PUR-1751
ADDENDUM NO. 5
INVITATION TO BID

HAGERSTOWN REGIONAL AIRPORT
EXPAND/REHABILITATE TERMINAL BUILDING EAST

DATE: Monday, June 23, 2025

EXISTING CONDITIONS AND DEMOLITION PLAN

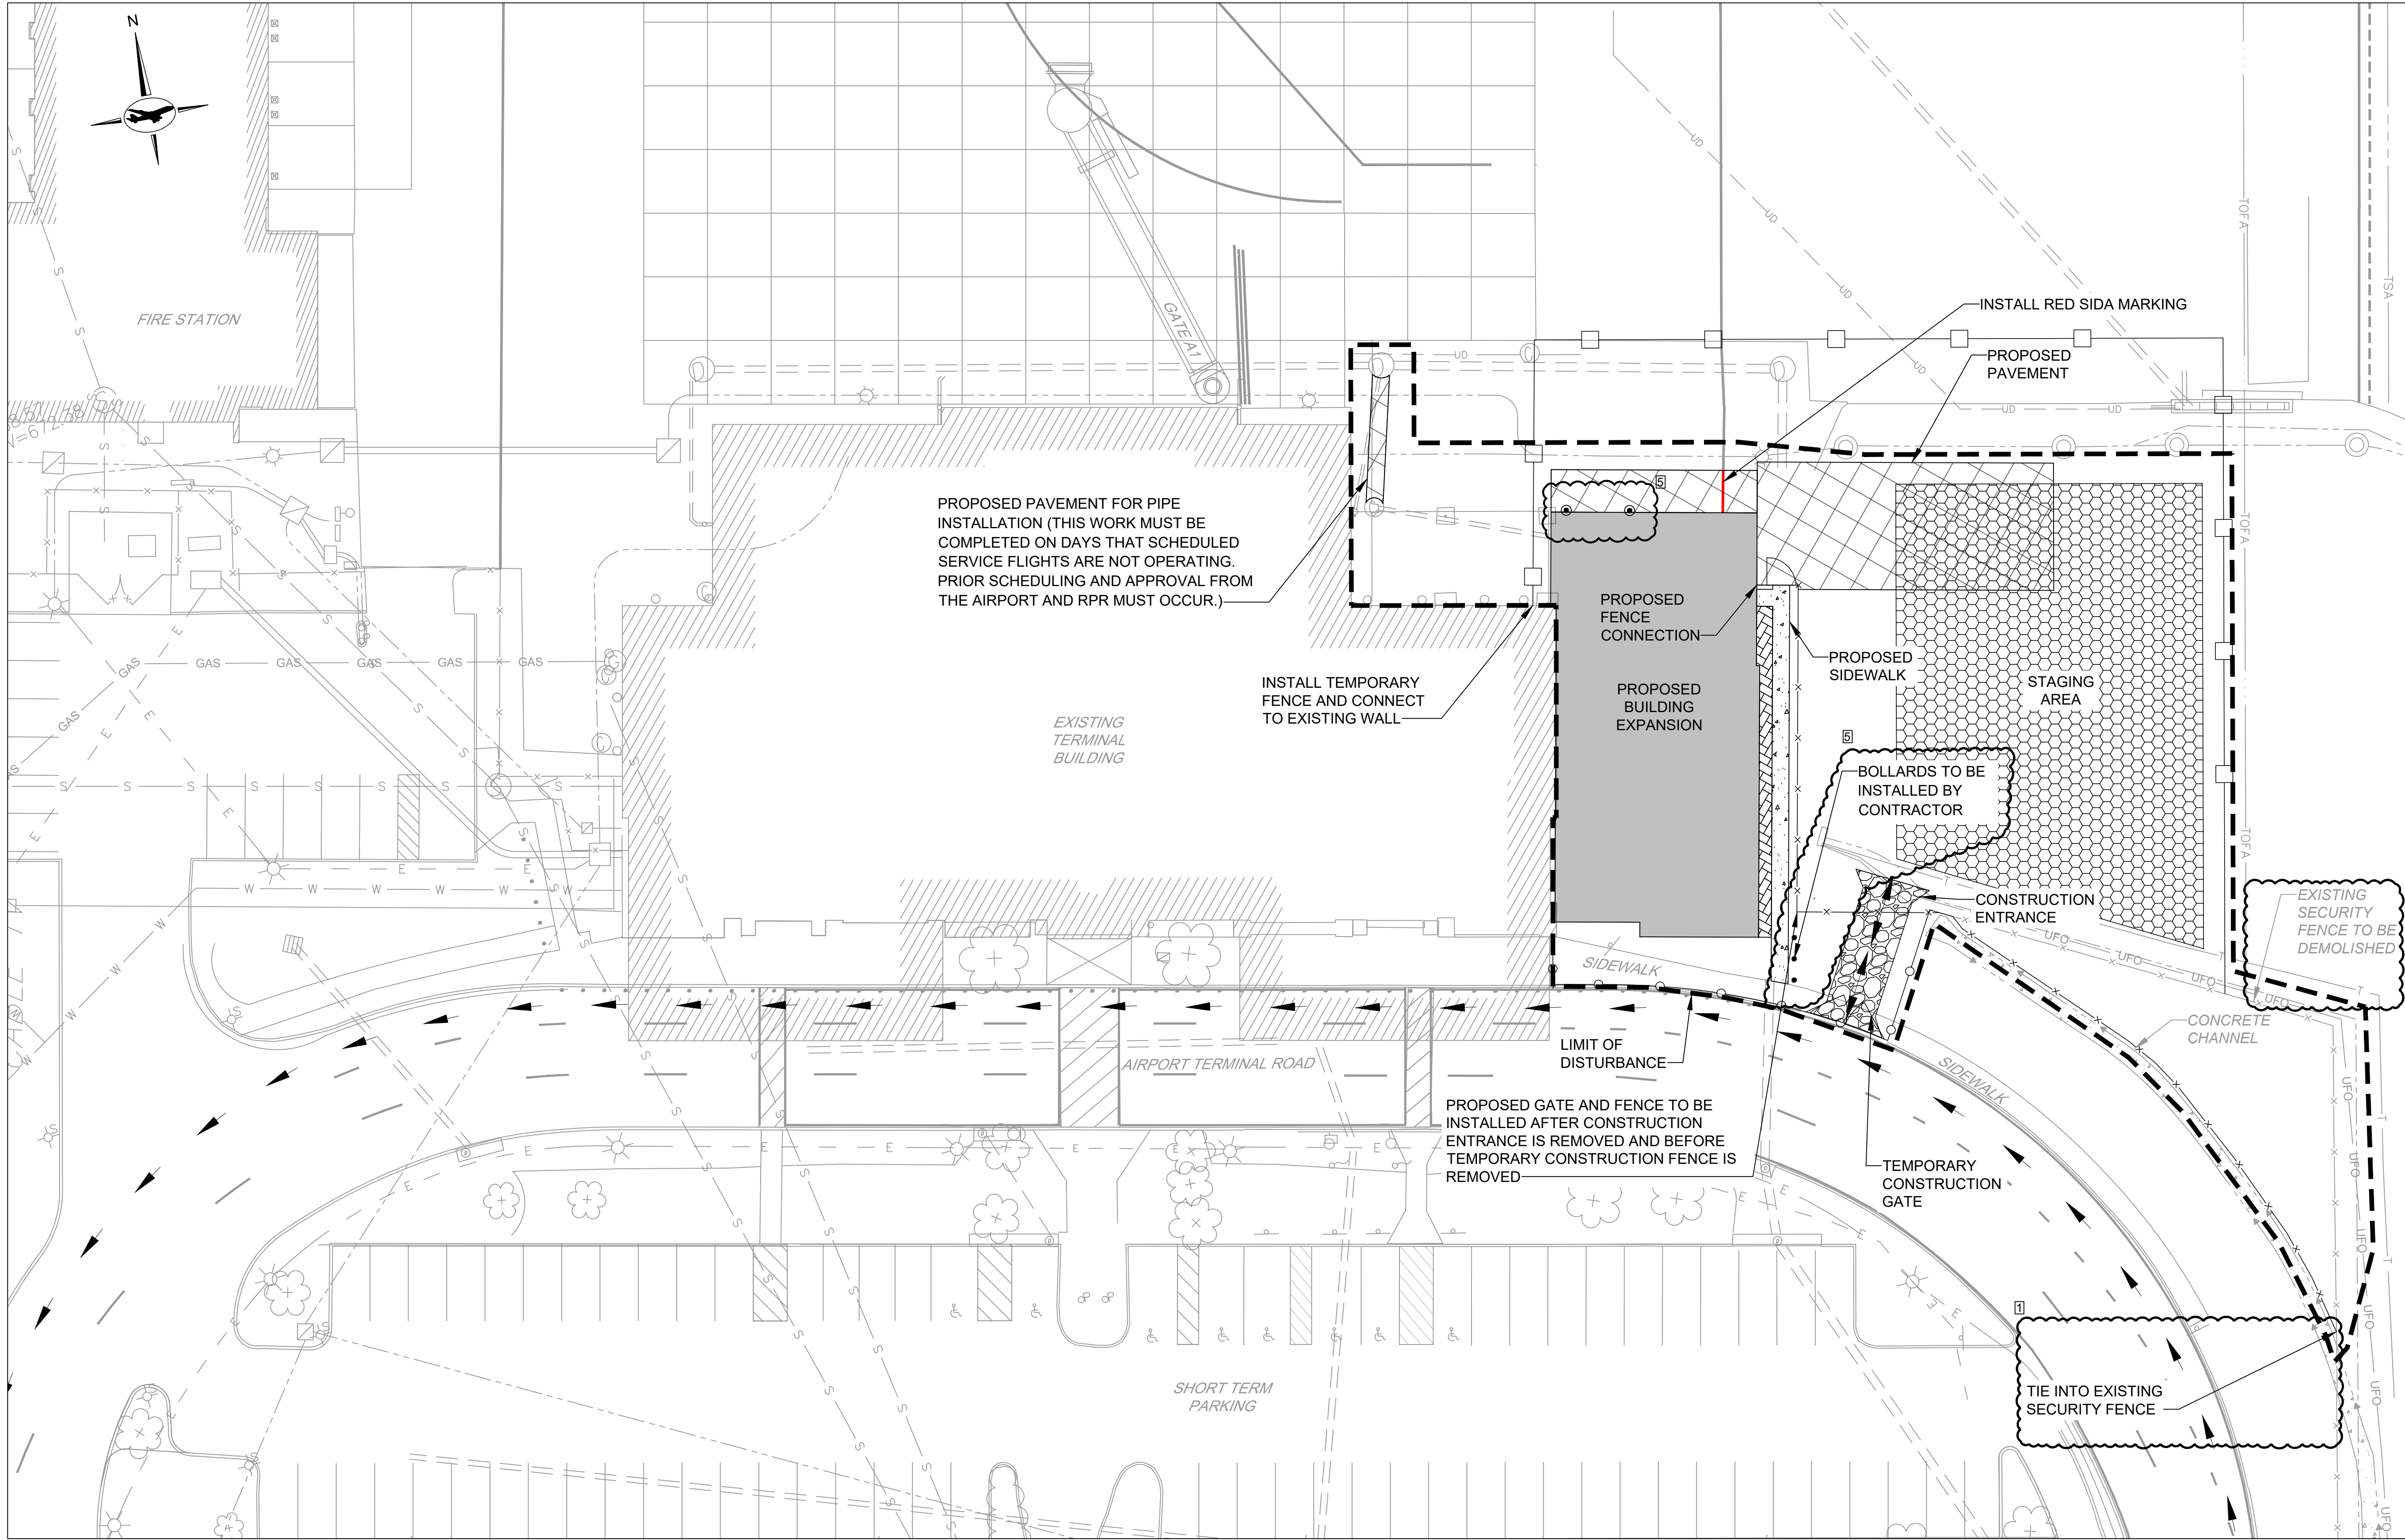
ITEM NO. 17: Inquiry: Refer to plan C1.0 - The conduits that are to be removed, what are they for and what cables are in them?

ITEM NO. 18: Inquiry: Refer to plan C1.0 - What size is the manhole that gets removed?

ITEM NO. 40: Sheet No. C1.0 Exiting Conditions and Demo Plan:
Updated the plan sheet to show removal of three (3) additional bollards.
REVISE Replace sheet in entirety with attached revised sheet.

Response: There are existing electrical power and fiber optic conduits originating from the existing terminal building and extending to the electrical rack located in the area of the terminal expansion. These existing systems must be disconnected, relocated, and reconnected as part of this project. Conduit contains power feeding the existing electrical rack. The other conduits contain fiber optic cables serving the access control system, parking lot security cameras, and gate control systems.

Response: The manhole to be removed, as shown on Plan C1.0, is an approximately 2' x 2' electrical manhole. It contains conduit and cabling that feeds power from the existing terminal building to the electrical rack. Contractor shall verify exact size and contents in the field prior to removal and ensure all associated power feeds are properly rerouted and reconnected as part of the work. (Attachment A)

UTILITY PLAN

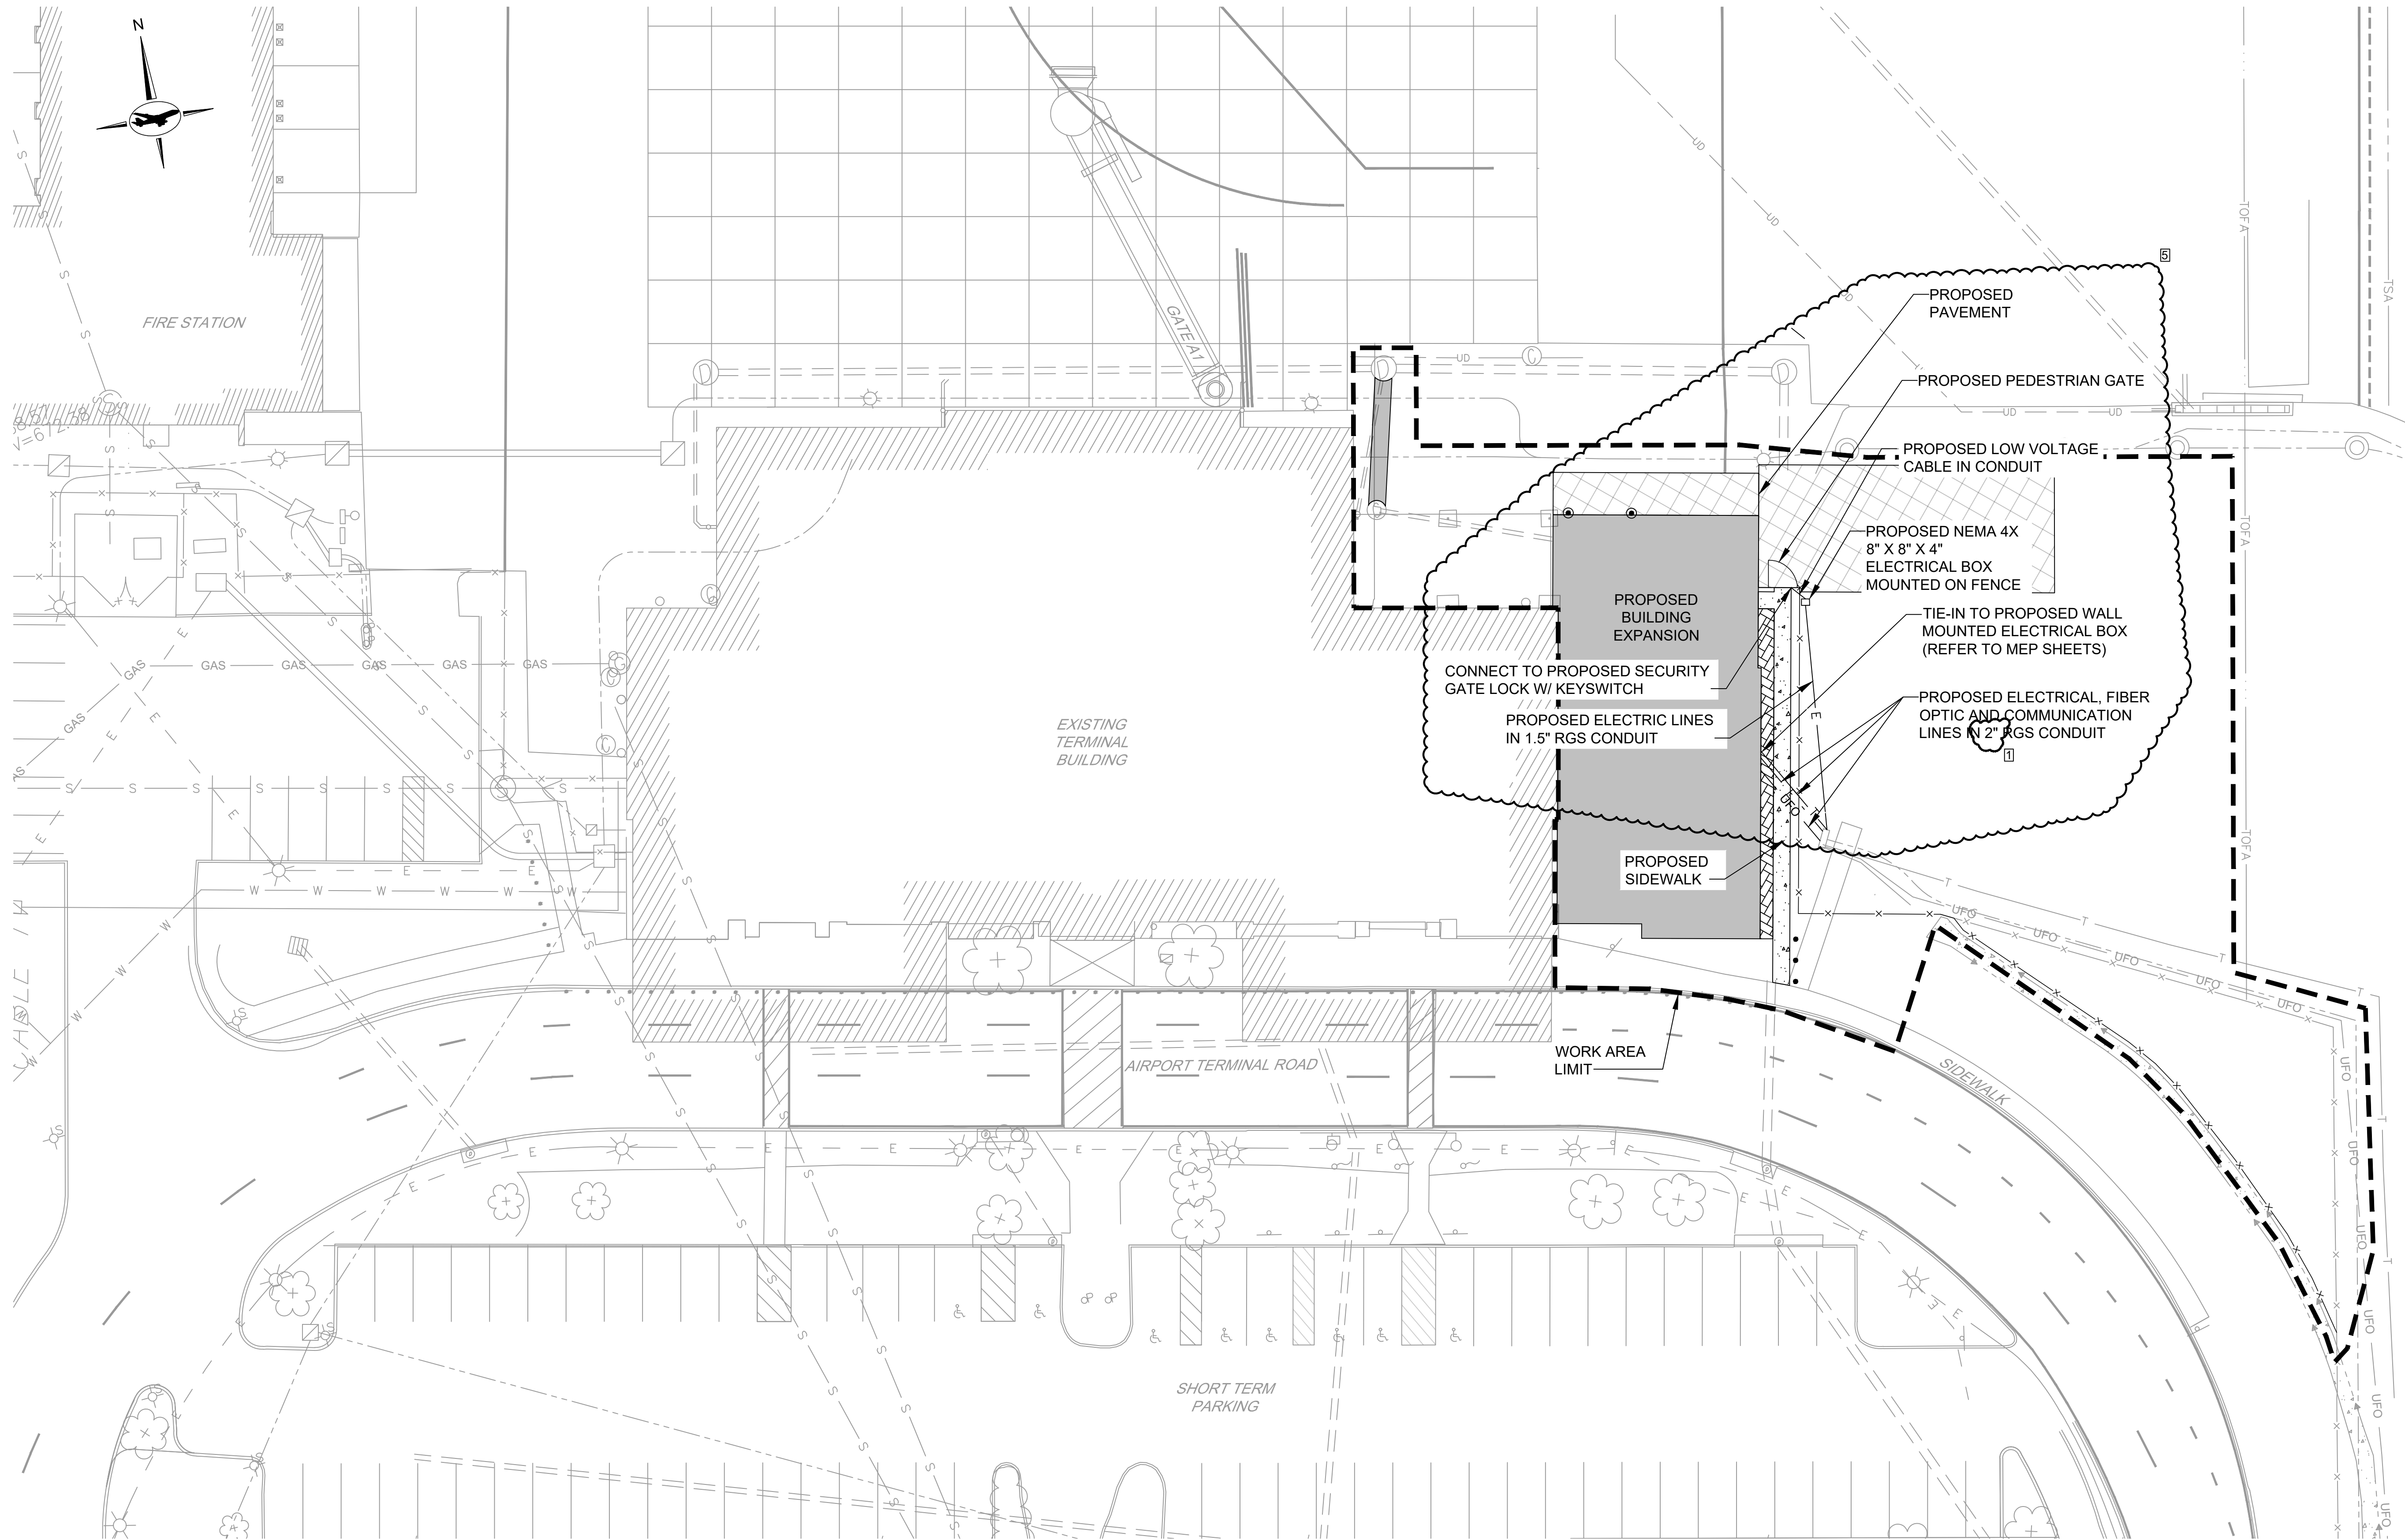
ITEM NO. 19: Inquiry: Refer to plan C1.3 - For the proposed Electrical, Fiber & Comm 4" RGS are there (3) conduits?

ITEM NO. 20: Inquiry: Refer to plan C1.3 - What MEP sheets show the tie-in to the wall mounted electric box?

ITEM NO. 21: Inquiry: Refer to plan C1.3 - There is a 1.5" RGS conduit for communication shown to the proposed Gate, is a conduit for power required?

ITEM NO. 43: Sheet No. C1.3 Utility Plan:
Updated plan sheet to depict electrical conduit/cable to proposed pedestrian gate with fence mounted electrical box.
REVISE Replace sheet in entirety with attached revised sheet.

Response: Only two (2) RGS conduits are required: One (1) for electrical power, and one (1) for fiber optic and communication cabling.

Response: This relocated wall mounted junction box is shown on plan sheet E1-1 - Demolition First Floor Plan – Electrical. (Attachment B)

Response: The 1.5" RGS conduit shown on plan sheet C1.3 shall be used for power to the proposed pedestrian gate. Communication cable is only needed from the electrical box to the electrical gate lock system mounted on the pedestrian gate. See Item No. 11 above. A REVISED sheet C1.3 Utility Plan is included. (Attachment A)
